<b>To</b>	Cindy Luxhoj, City of Wilsonville
<b>From</b>	Jennifer Arnold, Emerio Design
<b>CC:</b>	Amy Pepper, City of Wilsonville
<b>Date</b>	October 17, 2023
<b>Subject</b>	DB23-0012 Canyon Creek South Site Design Review of Tract A – Incompleteness Letter Response

Items listed in the October 5, 2023, incompleteness letter will appear in *italics*, followed by the applicant’s responses in regular typeface.

**TRACT 'A' PATH & ADA  
 RAMP GRADING PLAN &  
 PROFILE**

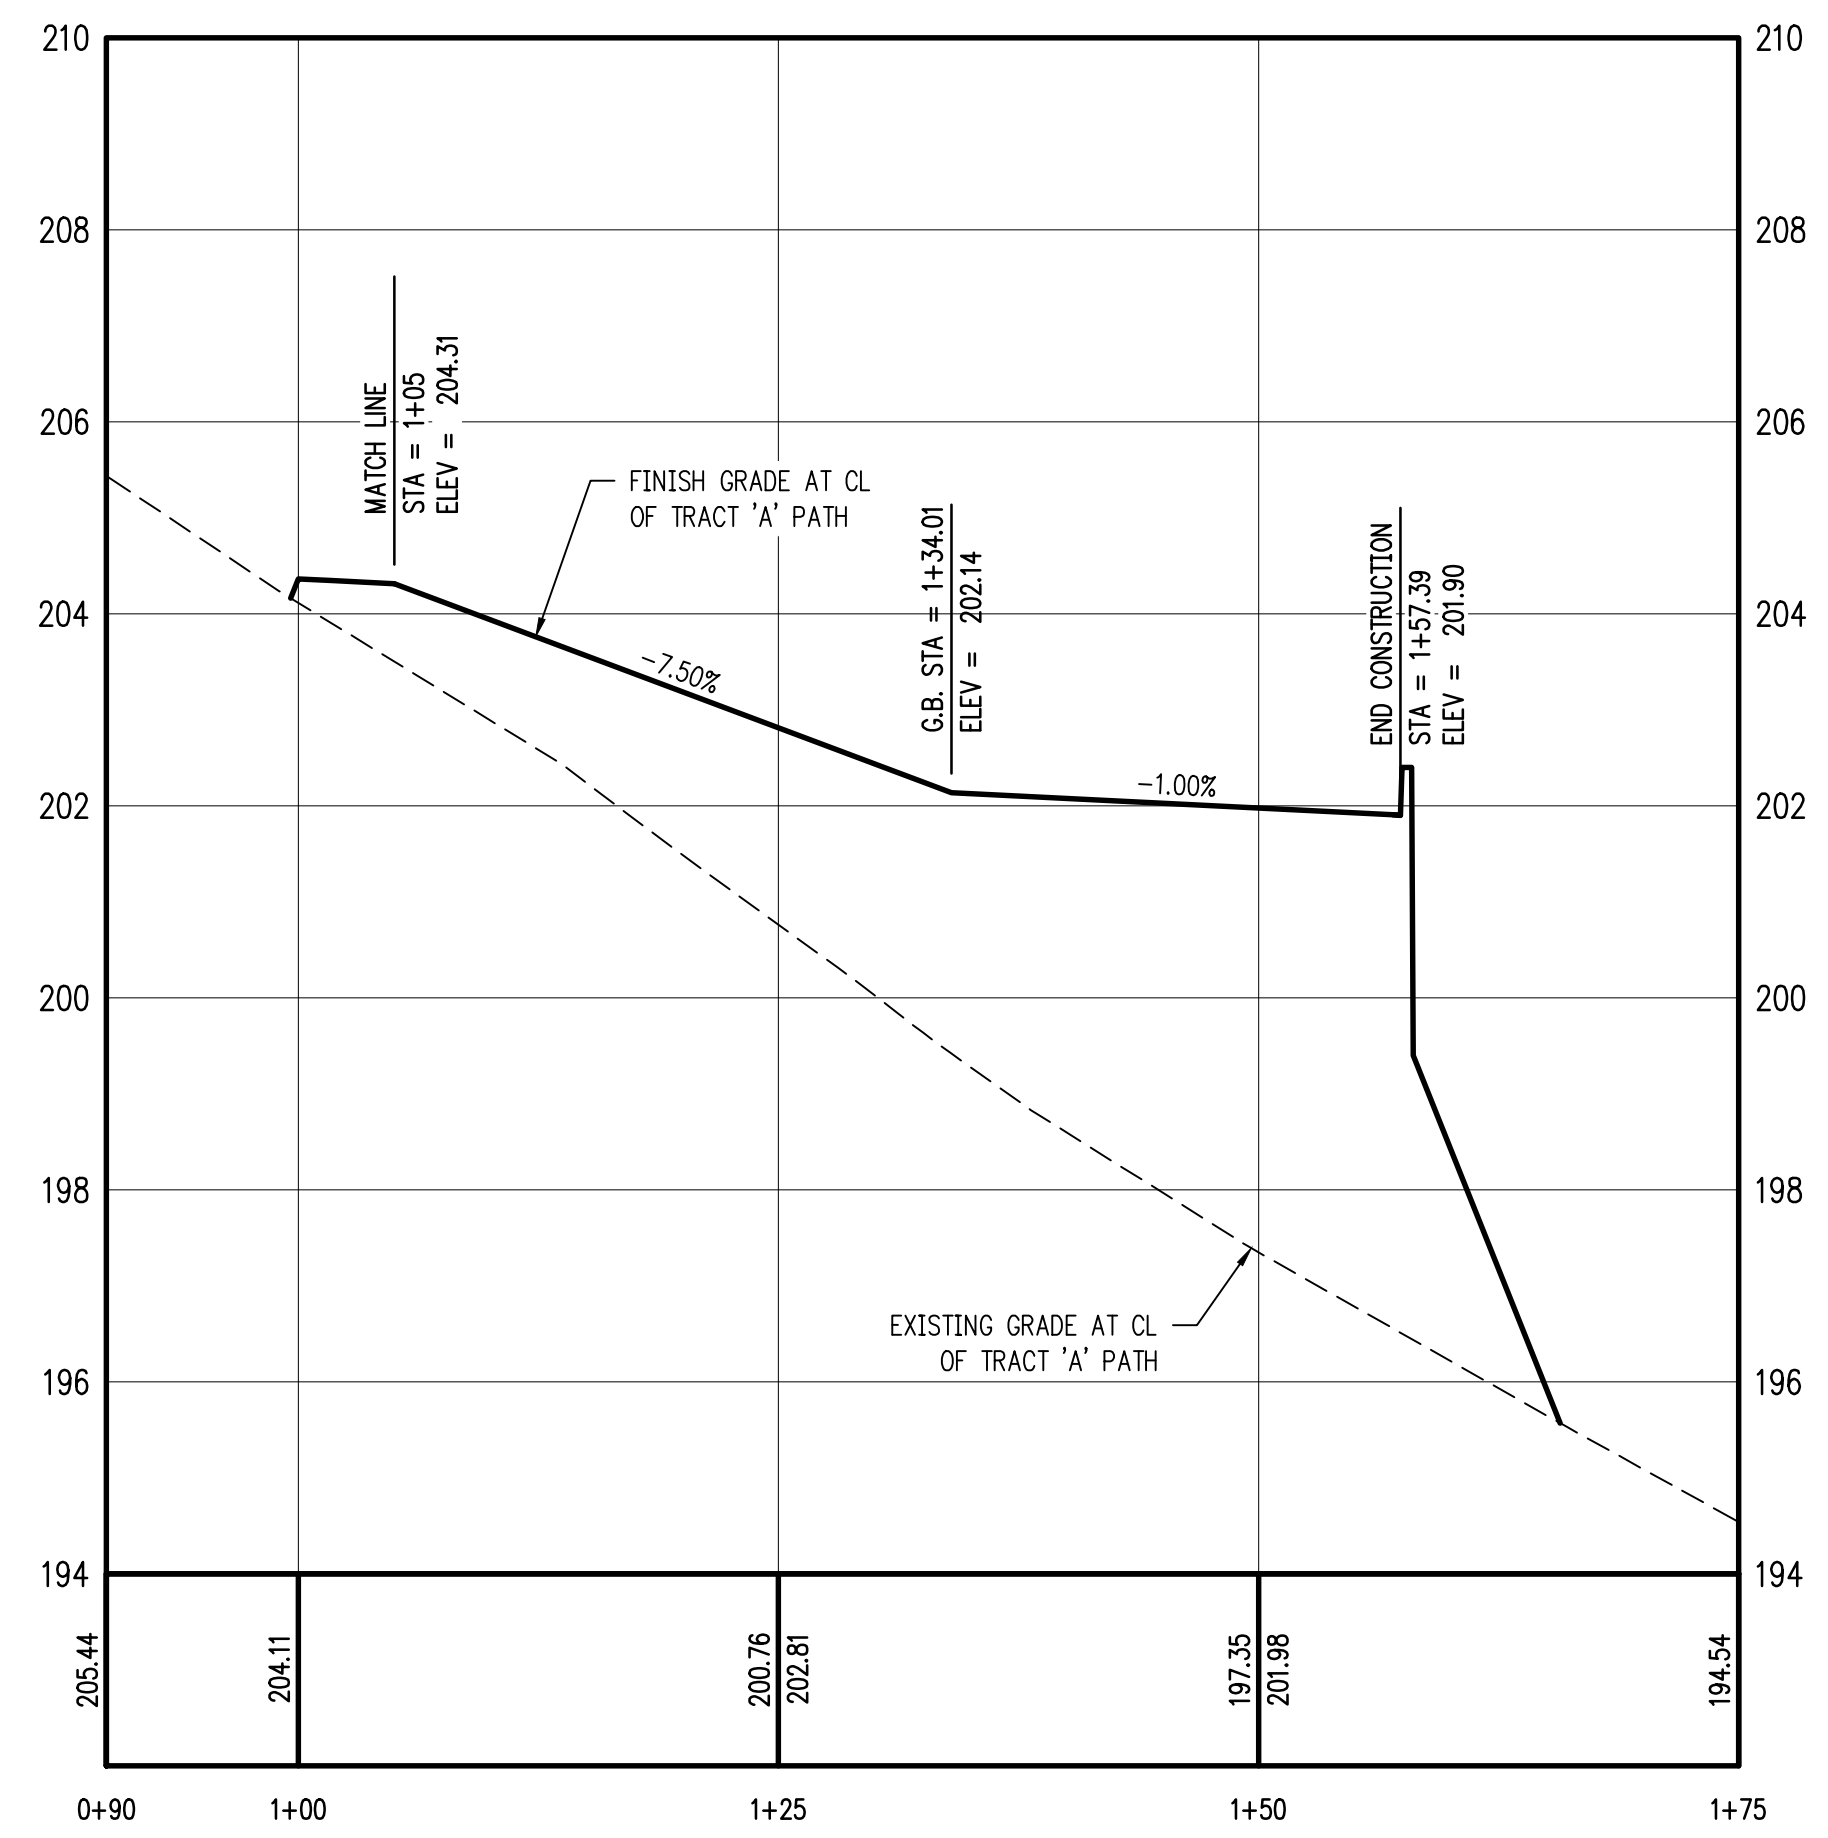
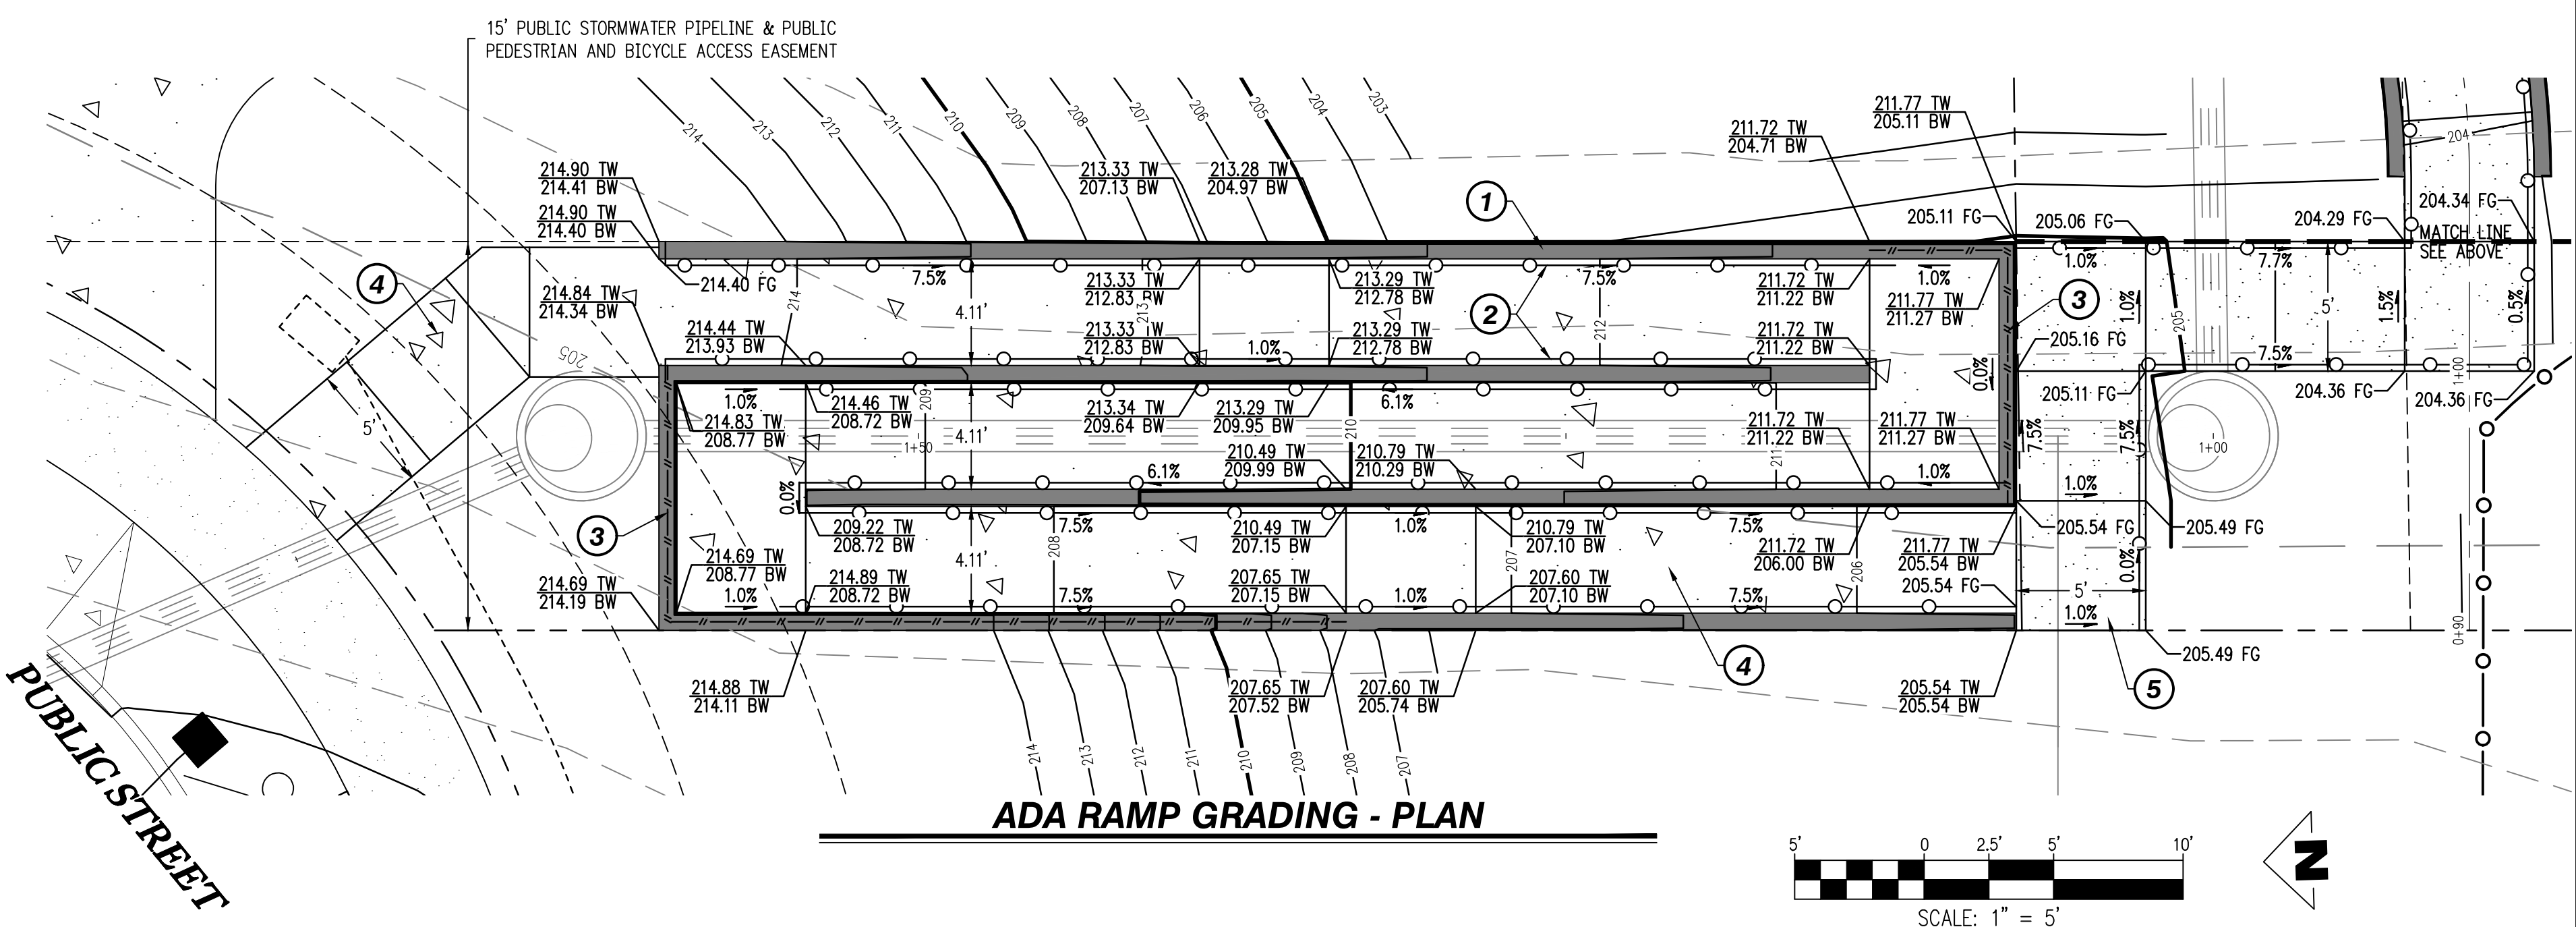
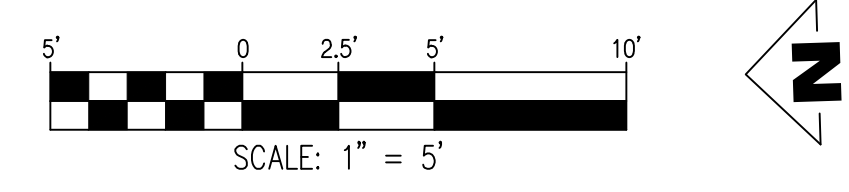
1. *Indication of how the concrete walk in the Tract A open space connects to the sidewalk in the public right-of-way. The pathway must be vertically or horizontally separated from the driveway in accordance with WC Section 4.154. The pathway must be ADA compliant. Submit a grading plan showing that the ADA pathway can be constructed as shown.*

**Applicant Response:** As included in Exhibit A, a grading plan showing pathway grades to demonstrate compliance with ADA standards. The driveway previously proposed at the public street has been changed to a 5 foot wide sidewalk that continues to Tract A.

Figure 5: Sidewalk Detail—Exposed Aggregate Concrete

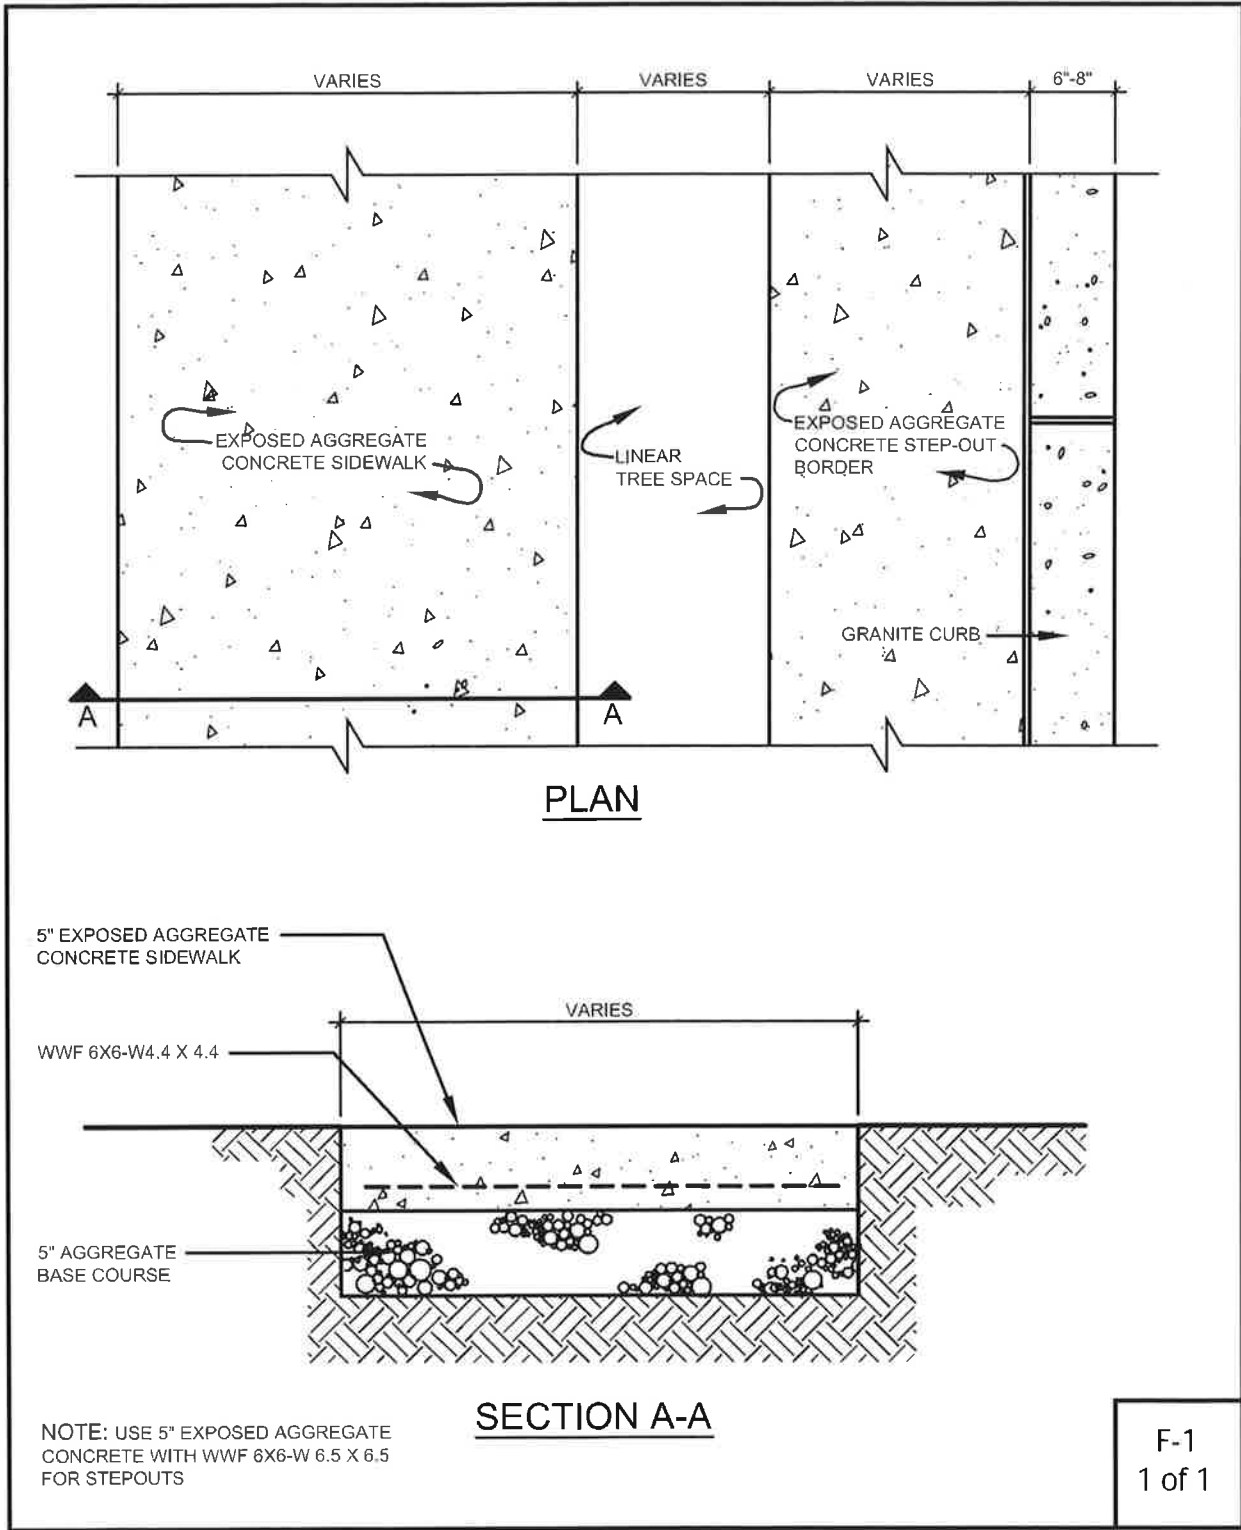
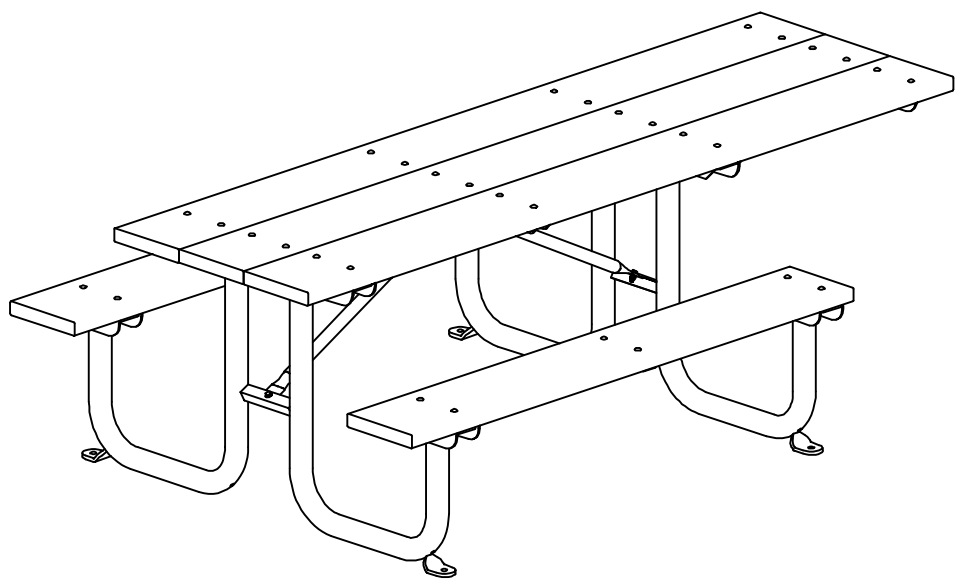
2. *Materials detail or cut sheet describing the surface treatment (“exposed pea-gravel aggregate finish”) of the concrete walk.*

**Applicant Response:** A detail of the exposed aggregate concrete sidewalk has been included as Exhibit B to address this comment.

PICNIC TABLE

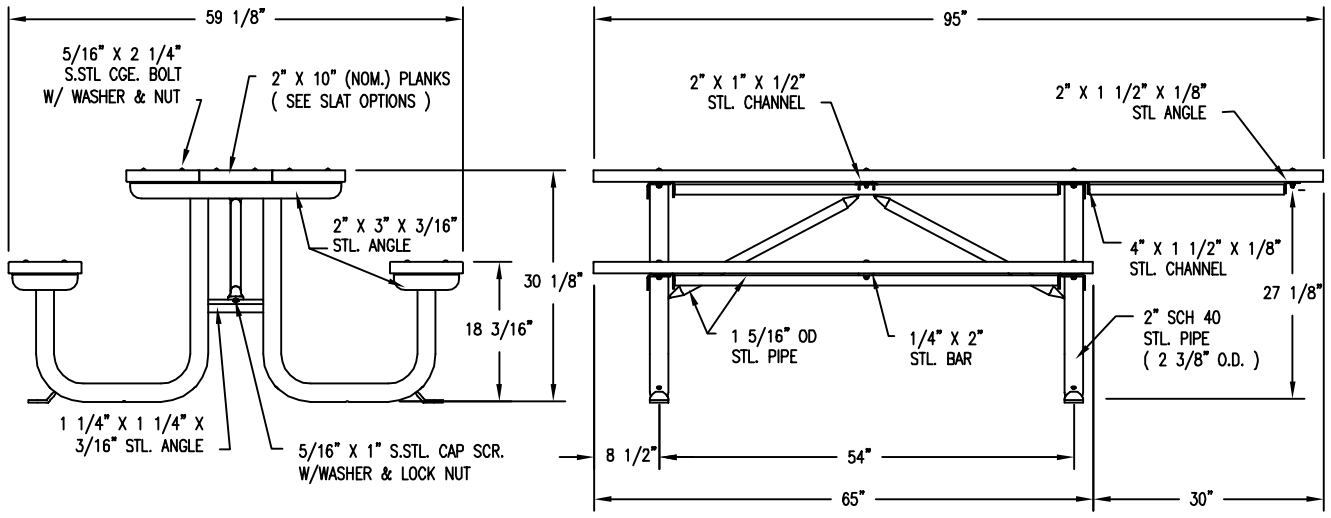
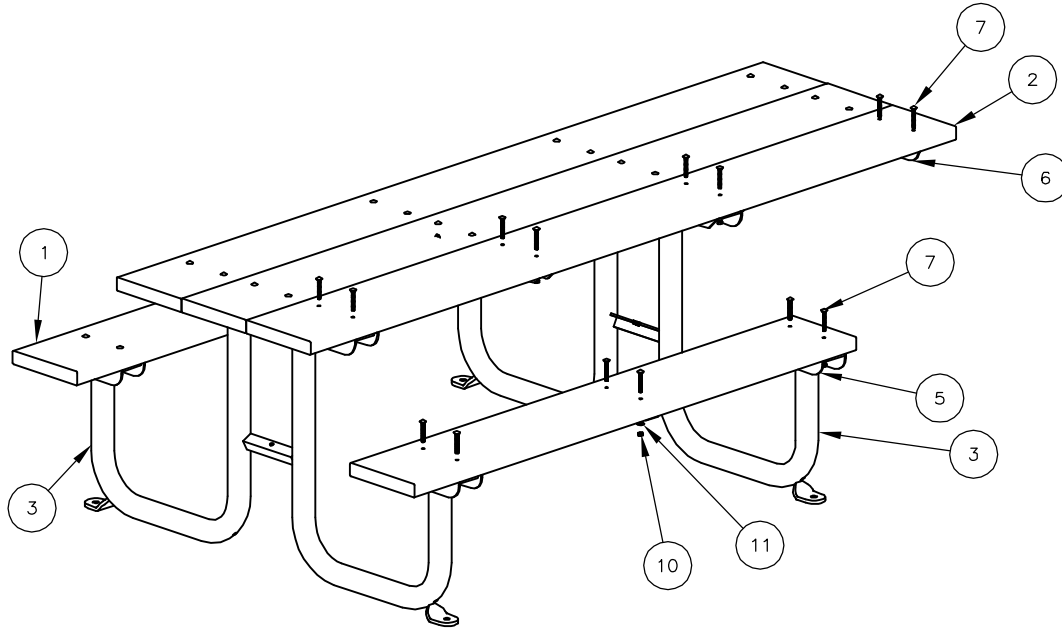
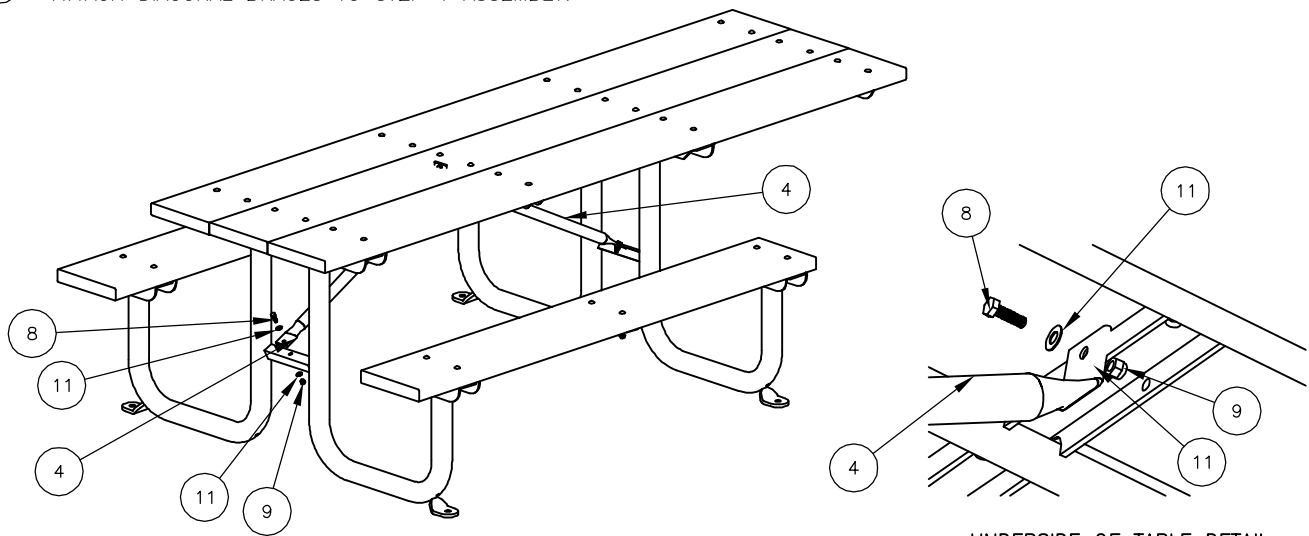
3. *Materials detail or cut sheet of the benches, picnic table, and any other site furnishings.*

**Applicant Response:** Included with Exhibit C are example images and detail sheets for both the picnic table and the benches. The example picnic table is intended to demonstrate material colors and materials but is not an ADA table as the detail specifies. The applicant proposes an ADA picnic table but had difficulty finding the appropriate image to match the detail.
